TECHNICAL CONSIDERATIONS OF THE  
EPA/PCB/NUS "CHANNEL" ALTERNATIVE

15
New Bedford
46
Order: 222690

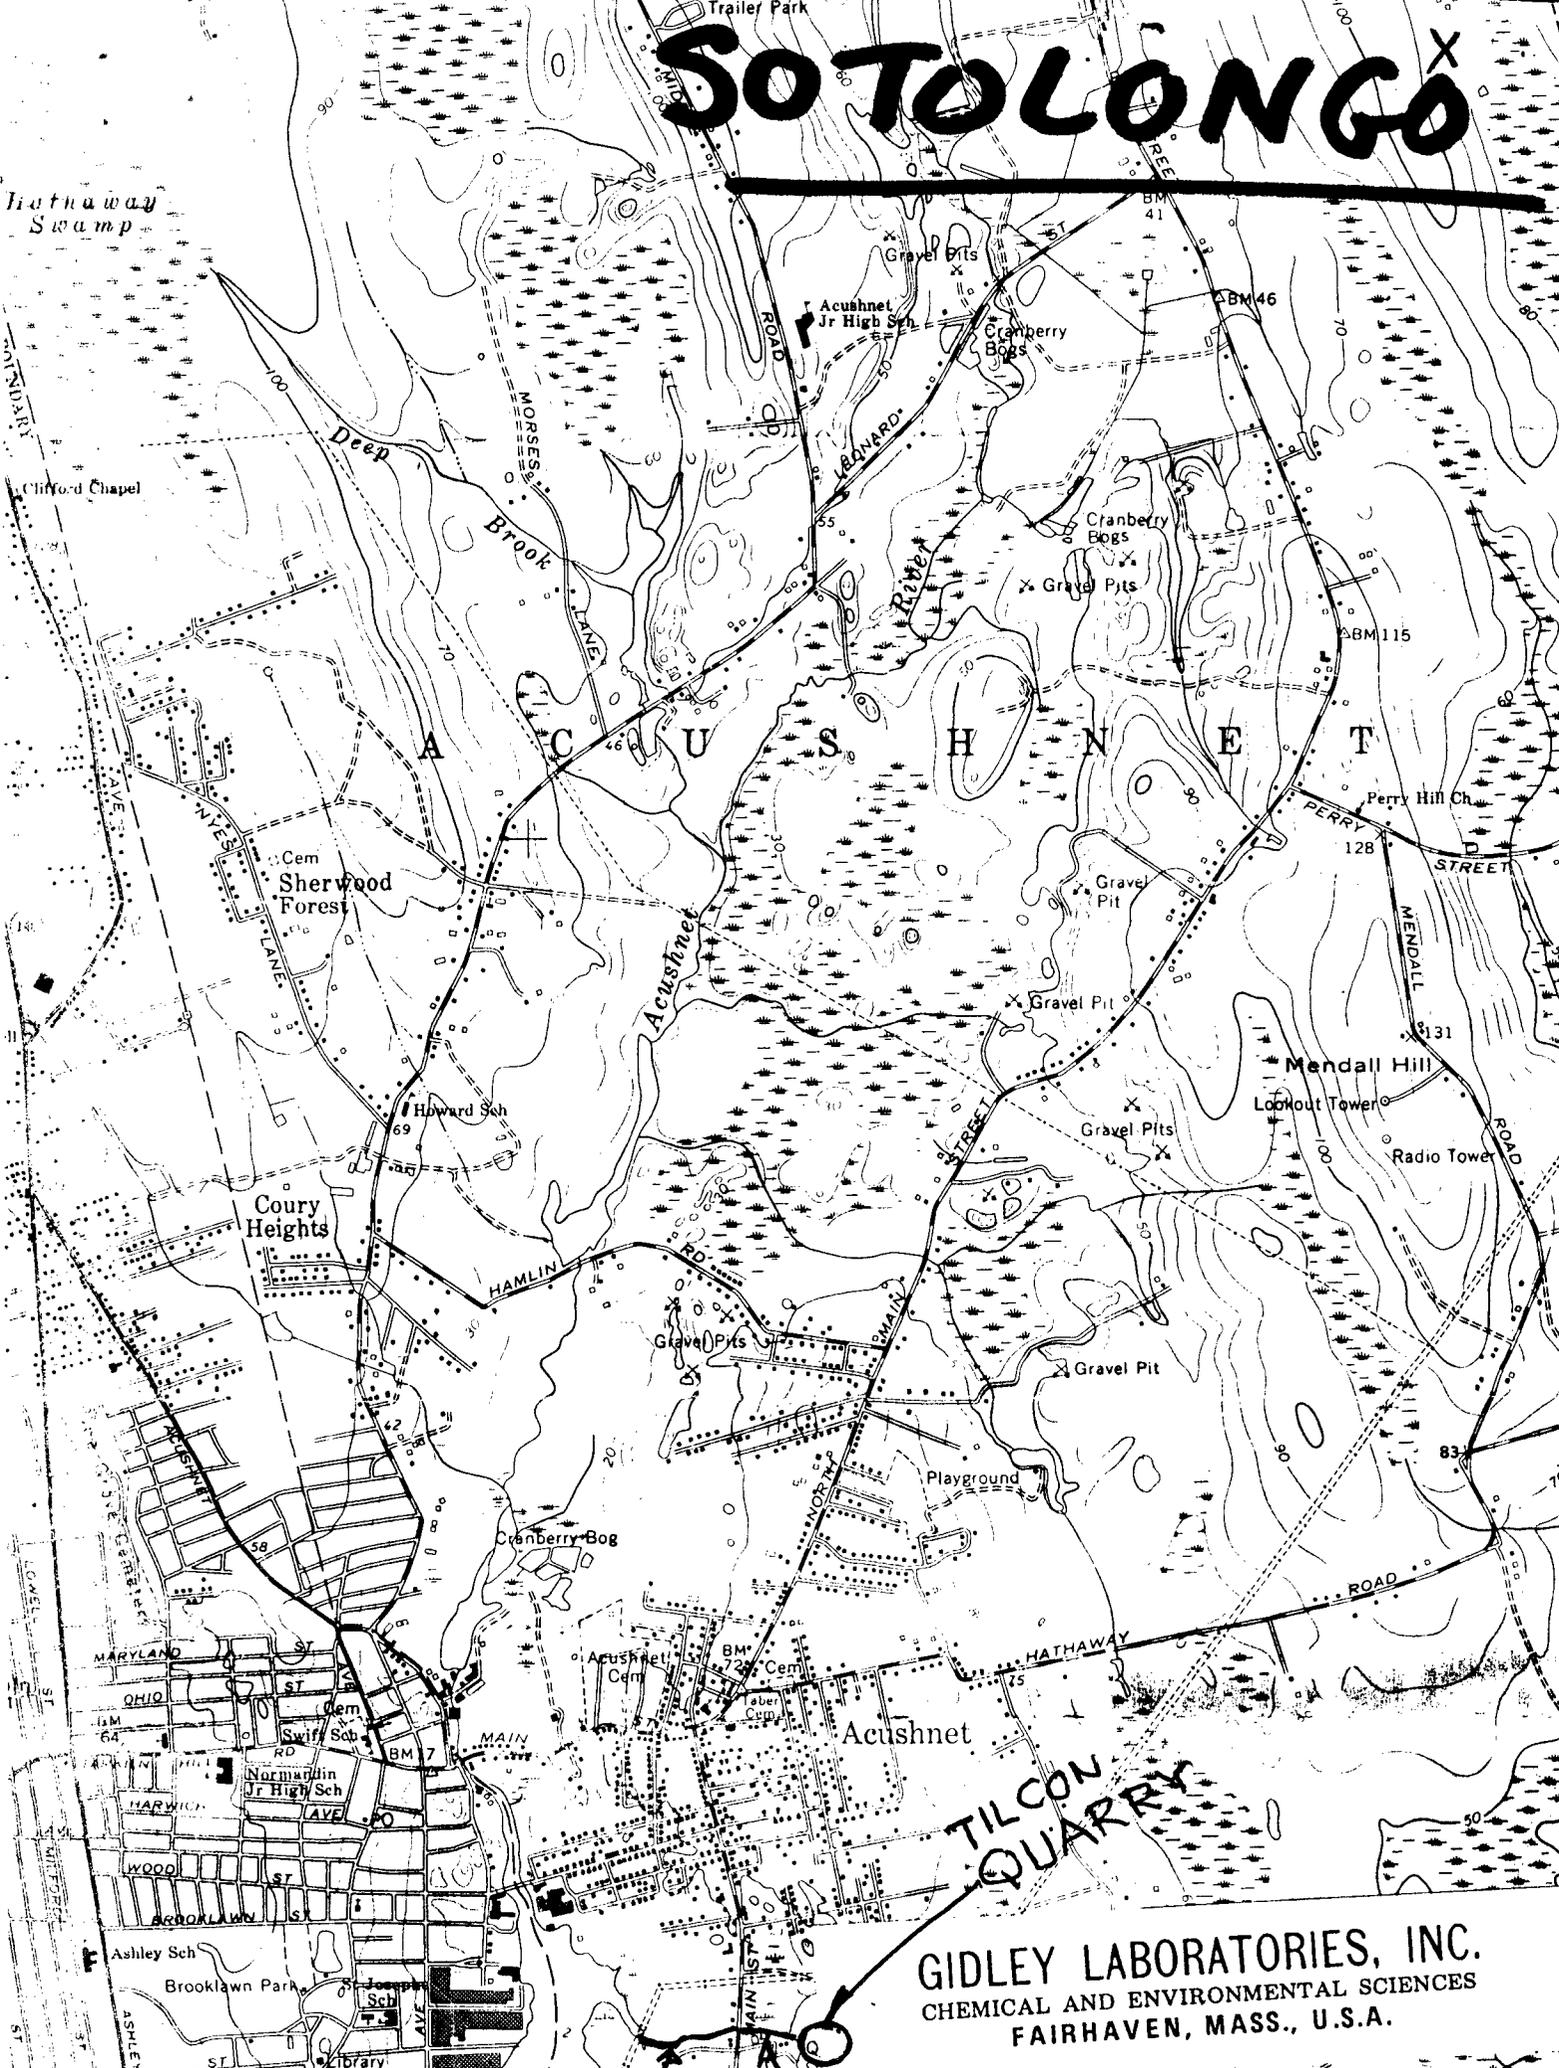
1. Evaluating and planning to control the effects and down-gradient flow of heavy rainfall (e.g., 100-year storm or hurricane) (acre-feet on the Acushnet River Watershed outside the "Channel").
2. Designing and controlling the water flow from storm drains (from Acushnet and Fairhaven; and from New Bedford respectively)—will these storm drains discharge into or outside of the "Channel"?
3. Disposition of discharge water from the Tilcon Quarry (now flowing into the Acushnet River)? **MAP ATTACHED**
4. Design, control and transit of the watershed drainage (outside the "Channel") through the Coggeshall Street barrier—without admitting tide-water backflow?
5. Problem of the design and control of the lateral "Channel" spillage as the "Channel" headwalls are lowered (NUS design) just before "Channel" walls reach the north side of Coggeshall Street abutment.
